WATER QUALITY MEMORANDUM

Utah Coal Regulatory Program

RE: 2008 First Quarter Water Monitoring, West Ridge Resources, West Ridge Mine, Task ID #3134

ST-5: Flow Values

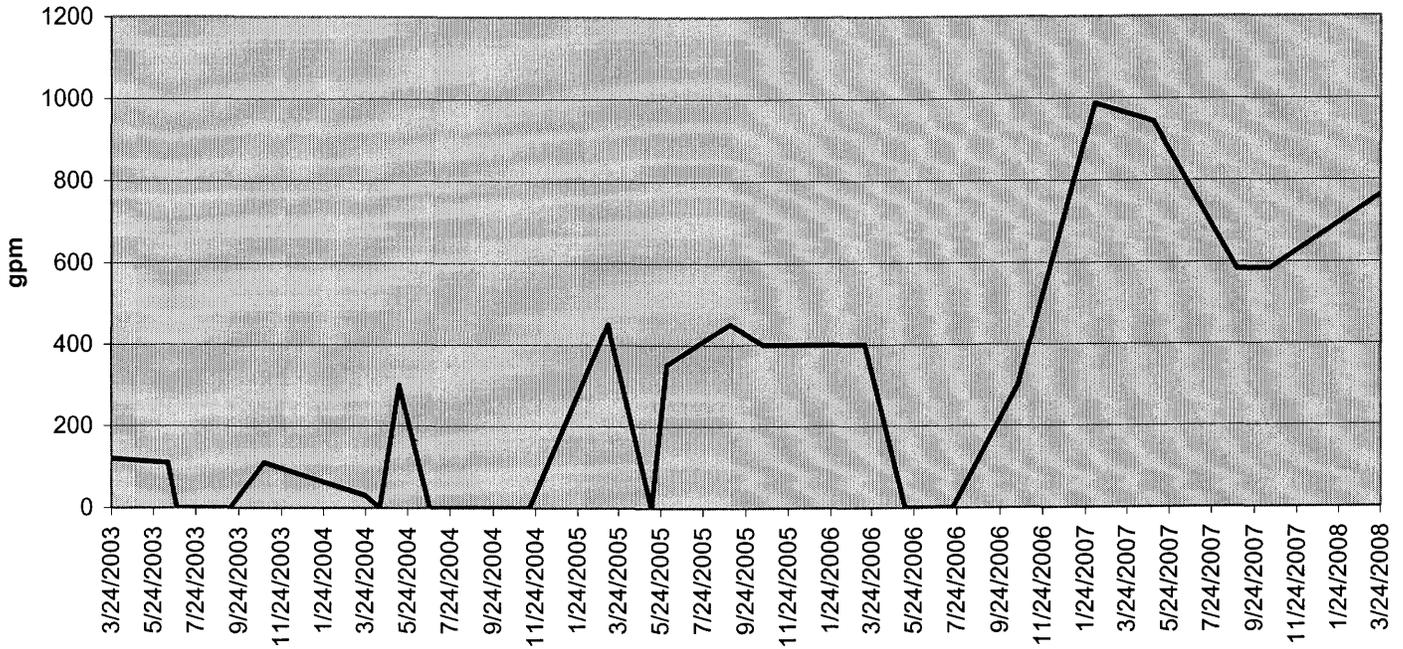
Surface water monitoring site ST-5 produced a flow value of 762.96 gpm, which is 2.10 standard deviations from the mean value of 133.22 gpm. One standard deviation is 299.76 gpm. The change in flow rate at this monitoring point is likely due to alterations/changes in the underground condition within the mine workings. The increase in flow at ST-5 is inconsistent with the flow value obtained at the upstream site ST-6. As the primary source of water within the 'C' Canyon drainage is the mine-water discharge, a similar increase in flows at ST-6 should've been reported as well.

Look to see if the increased flow value for ST-5 continues or begins to correlate with flow values obtained at upstream monitoring site ST-6.
